ADDENDUM 1

DATE: 07/30/2018
PROJECT: Simulation Lab Renovation
ITB NO: 744-R1825
OWNER: The University of Texas Health Science Center at Houston
TO: Prospective Proposers

PROJECT'S NAME: Simulation Lab

Documents have been updated to reflect coordination, constructability review, building envelope review and UTHSC review. See list of documents below and attached narrative of changes.

A3.1A

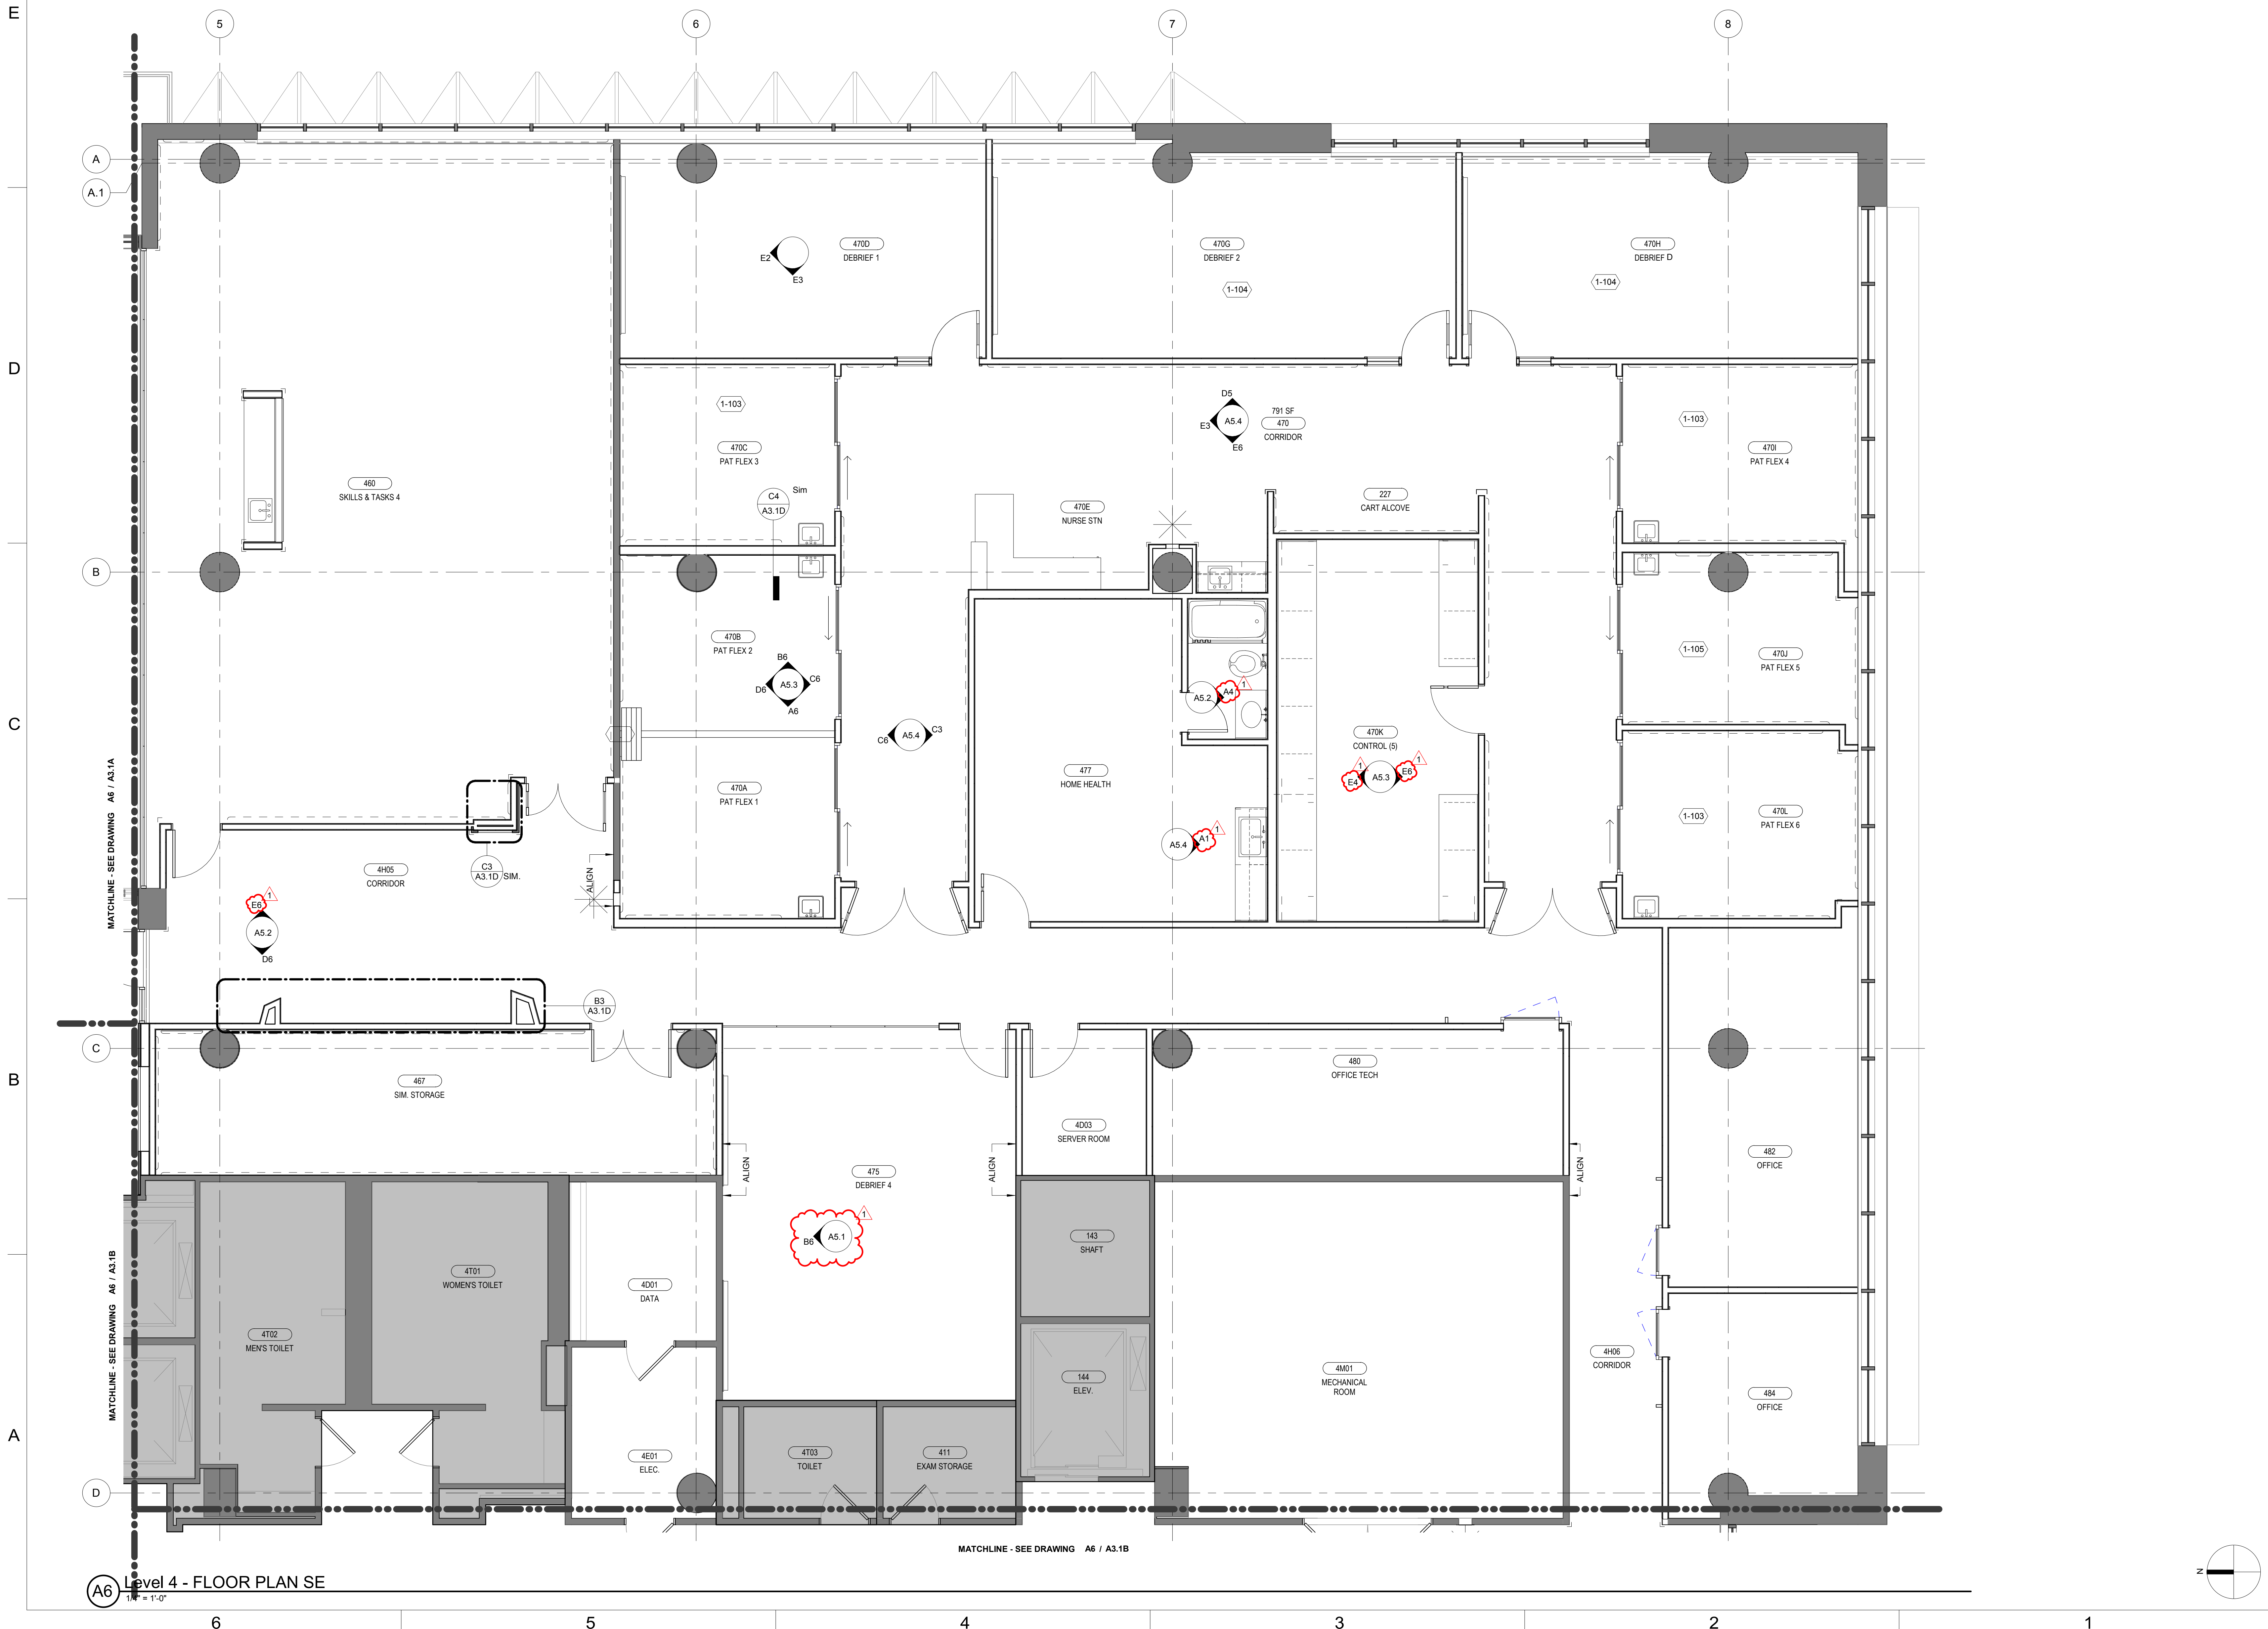
ARCHITECTURAL:		DESCRIPTION
SHEET	VIEW	
A0.01		Sheet index updated.
A3.1A		Sheet index updated.
A3.1C		Elevation references updated.
A3.1D		Elevation references updated.
A4.1A		Sections and elevations added to RCP.
A4.1B		Sections added to RCP.
A5.1		Notes to sheet updated. Elevations added.
A5.2		Dimensions added to elevation A4.

M2.1

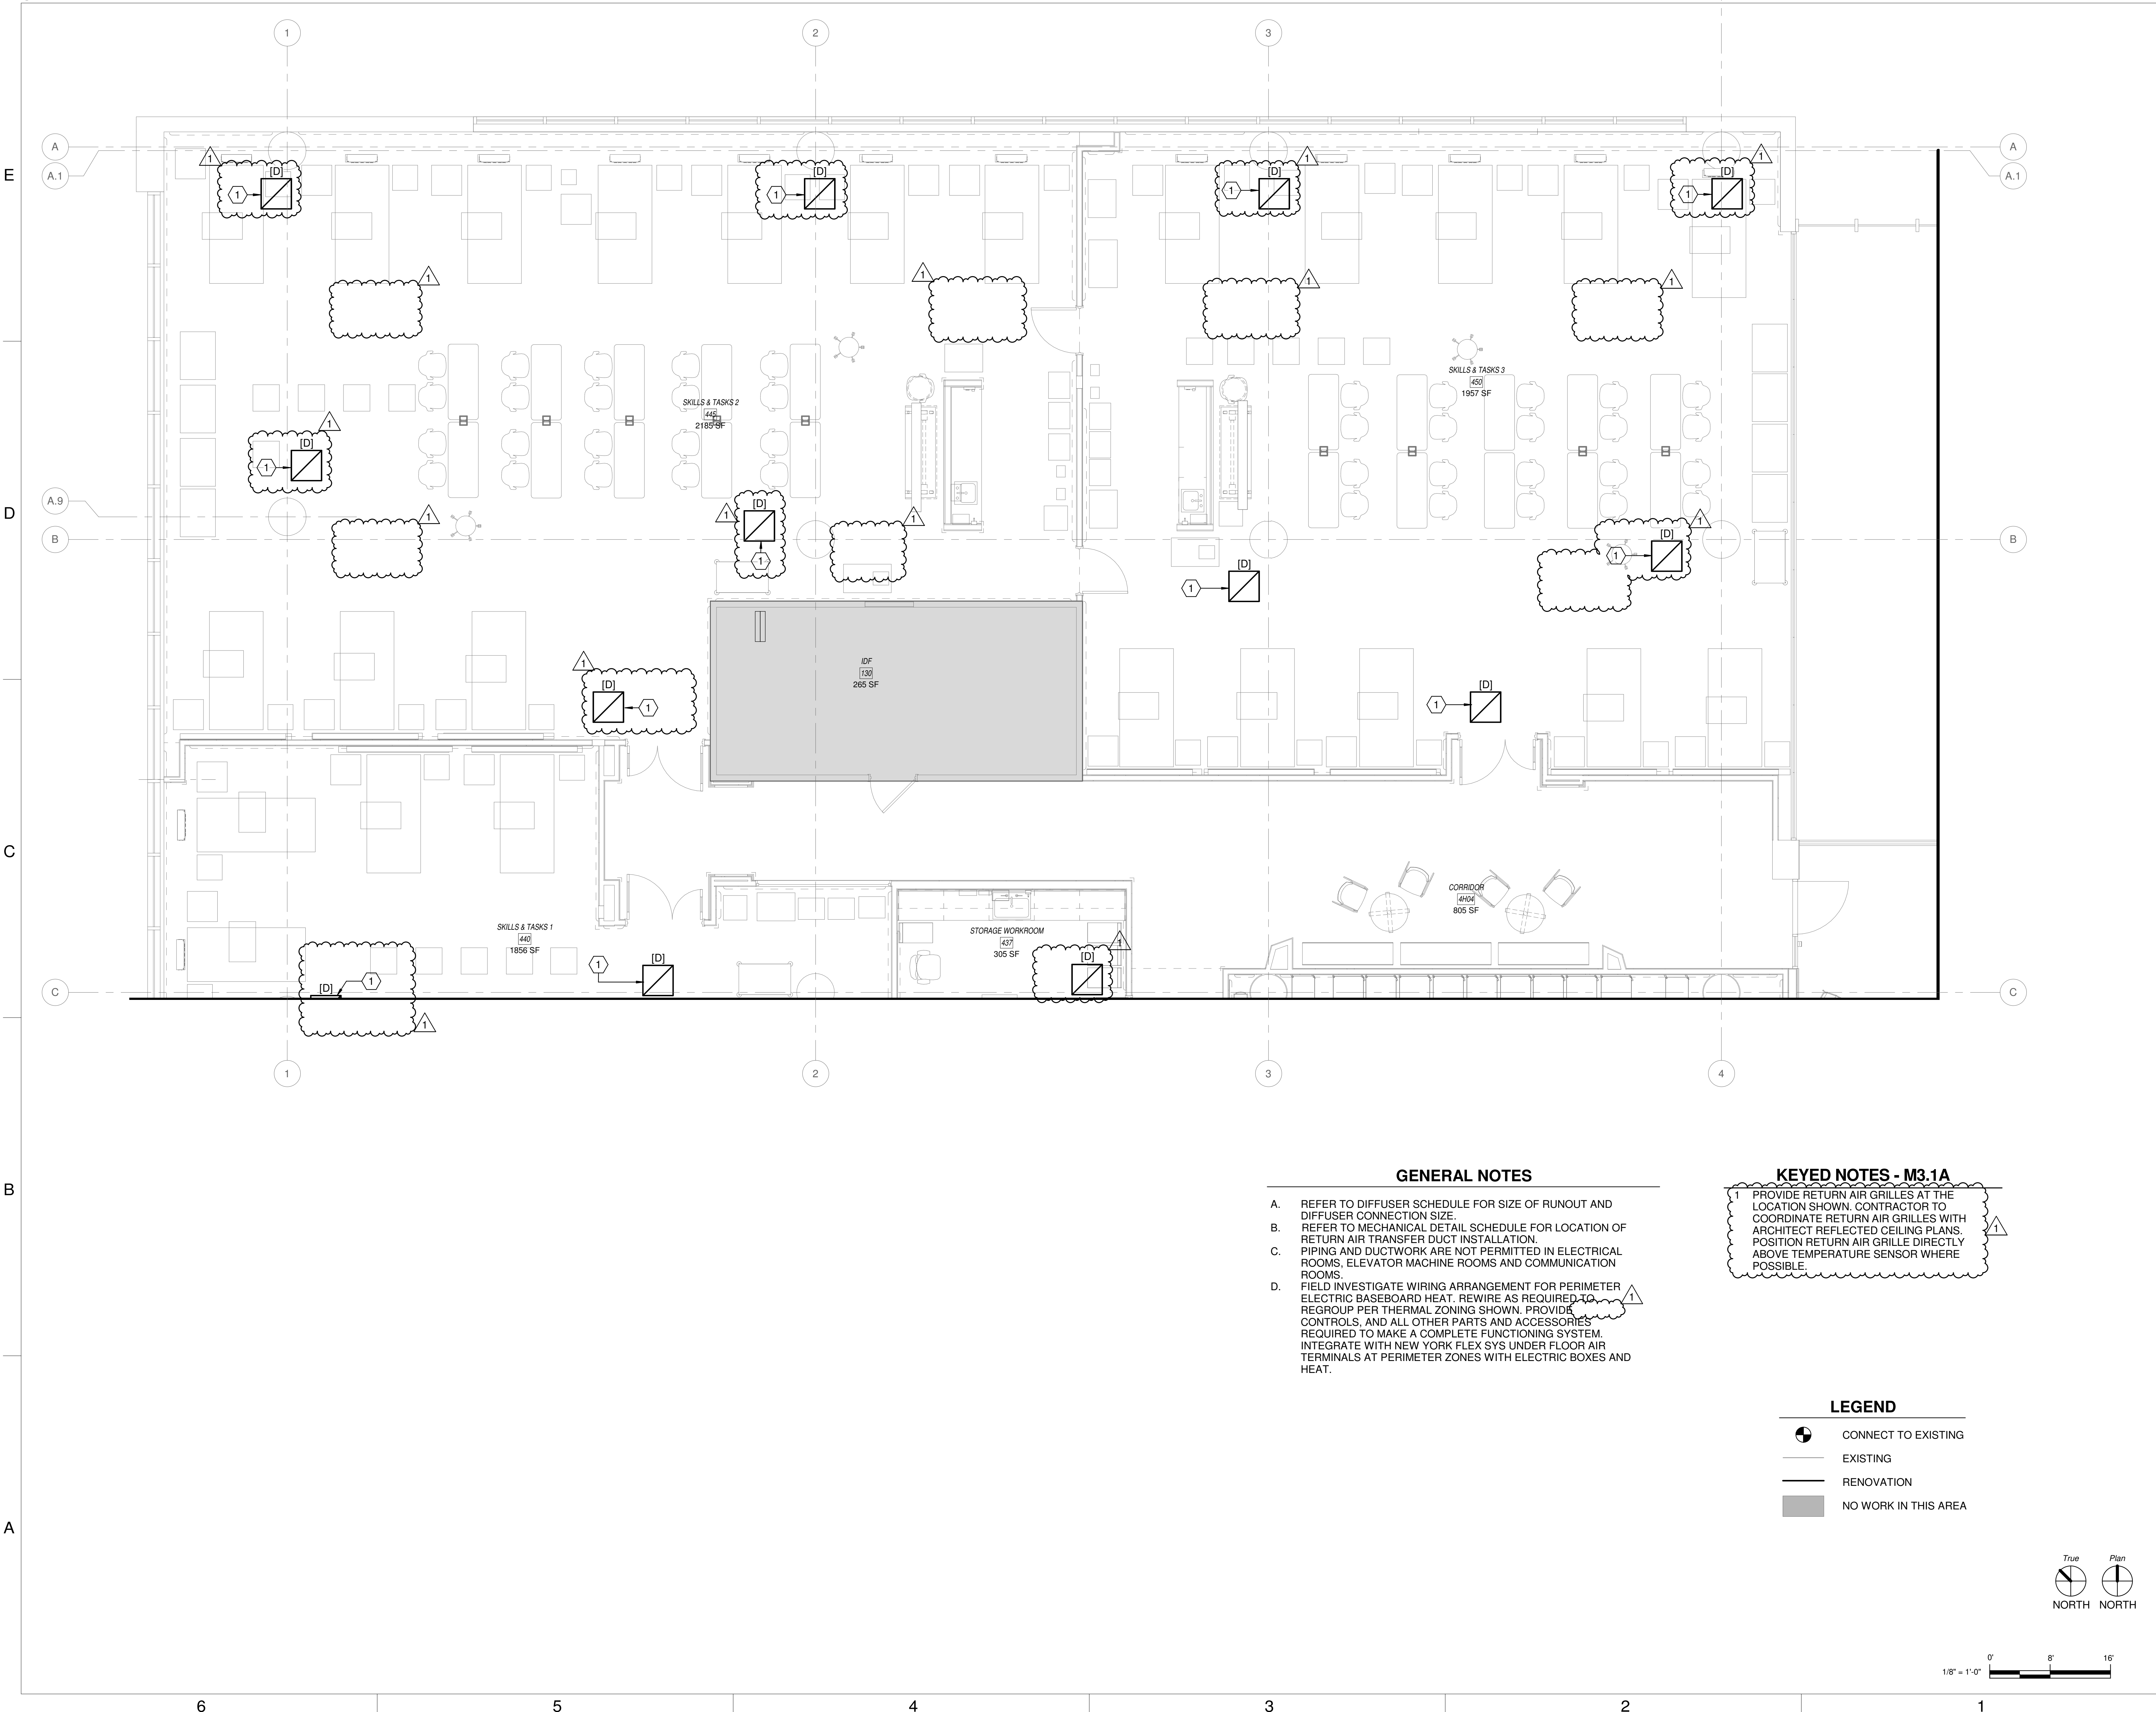
SHEET	VIEW	DESCRIPTION
M0.1		Revised room number on the fan coil unit schedule.
M.03		Added terminal box nomenclature. Added room number to terminal box schedule.
M1.1		Revised keyed notes 1 and 2.
M2.1		Revised general notes, paragraph B. Revision for the fabric ductwork, return air grilles and baseboard heaters, is described in the larger sections.
M3.1A		Revised keyed notes #1. Relocate number of return air grilles to be above temperature sensor.
		Revised general notes, paragraph D.
M3.1AU		Revised keyed notes number 4. Revised general notes, paragraph G. Revised fabric ductwork to three duct runout at 16" round. Relocate underfloor terminal boxes from under patient beds.
M3.1B		Revised keyed noted #3. Relocate number of return air grilles to be above temperature sensor.
M3.1BU		Revised keyed note #5. Revised general notes, paragraph G. Relocate underfloor terminal boxes from under patient beds.

6 UNDERFLOOR TERMINAL BOX ASSEMBLY
NO SCALE

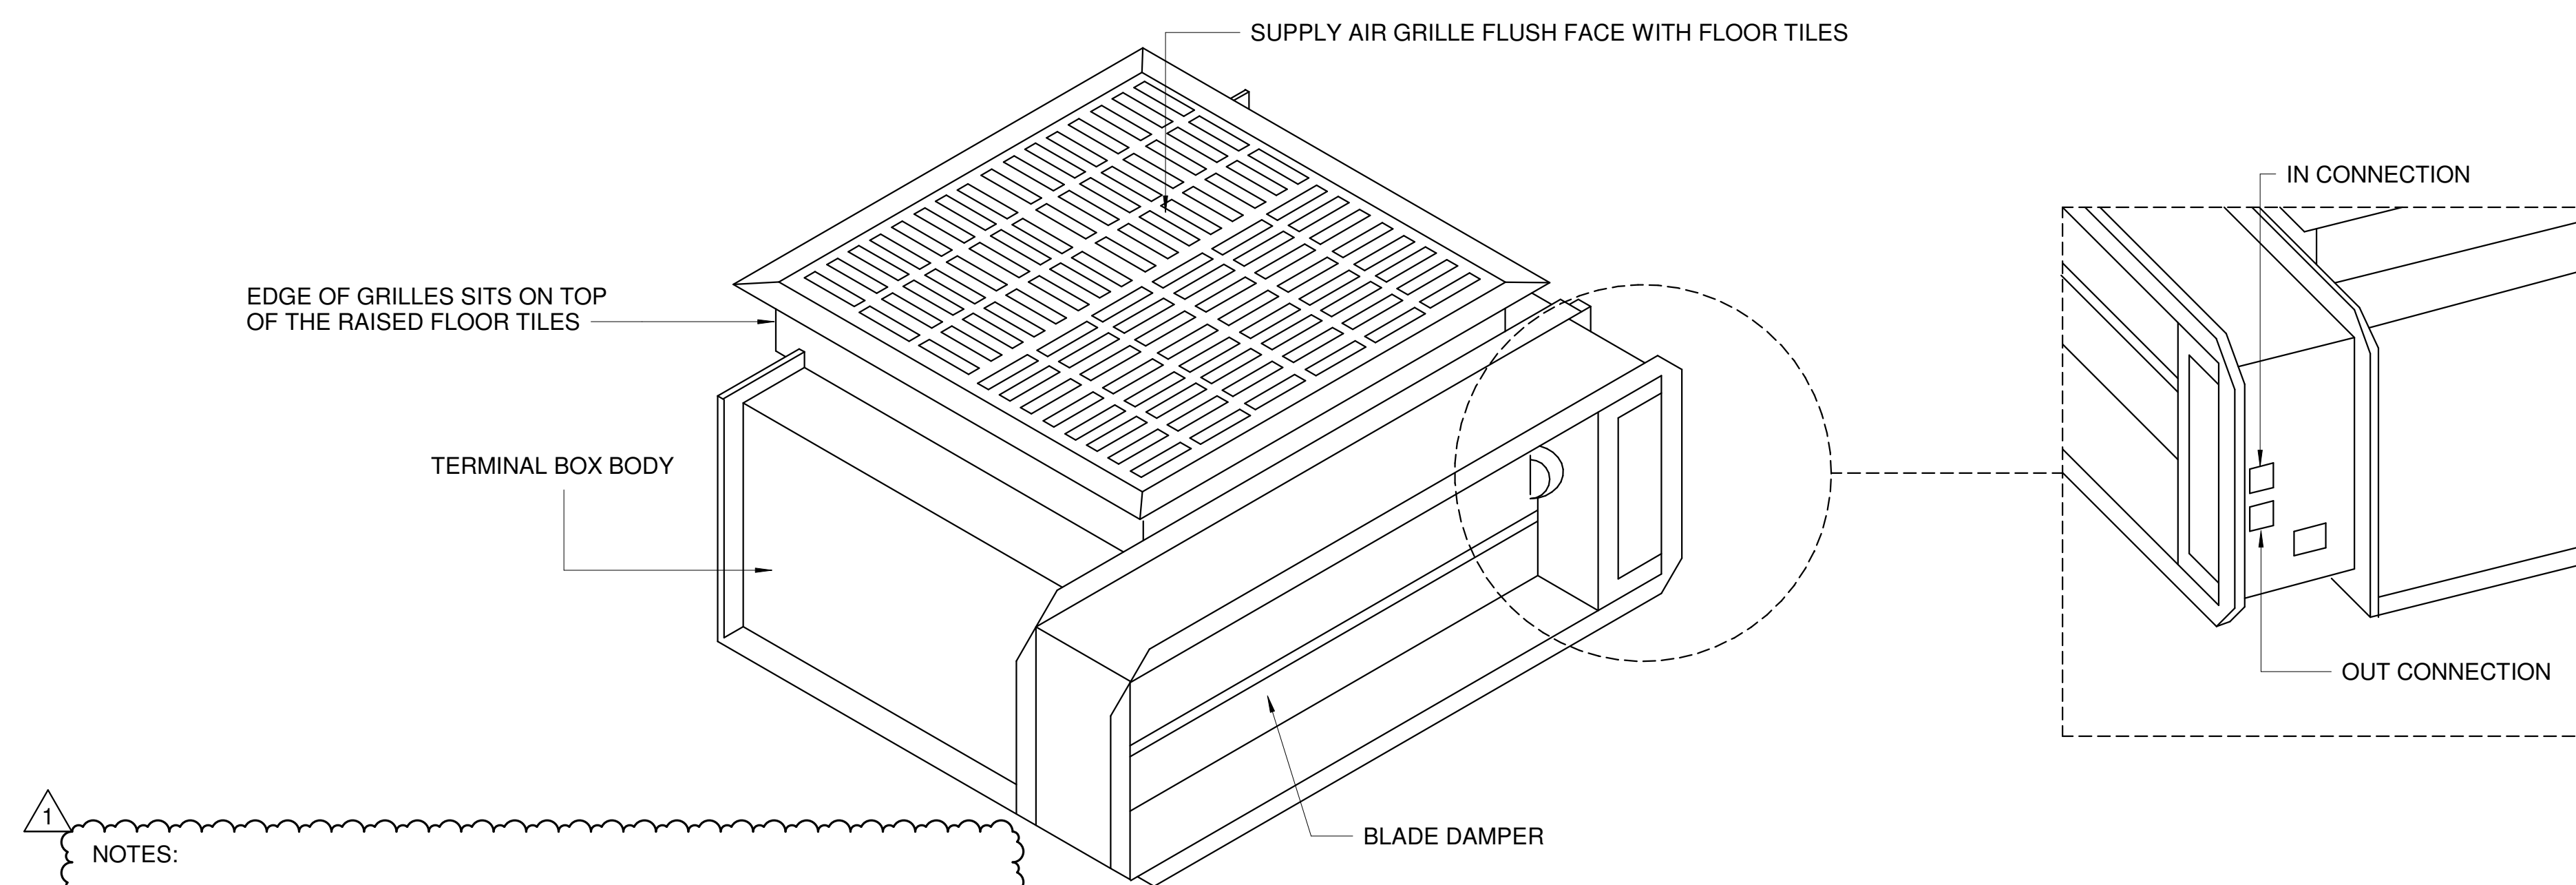
- M3.1DU Added keyed notes #9.
Revised general notes, paragraph G.
Relocate underfloor terminal boxes from under patient beds.
- M7.2 Added notes to terminal box mechanical detail #6.
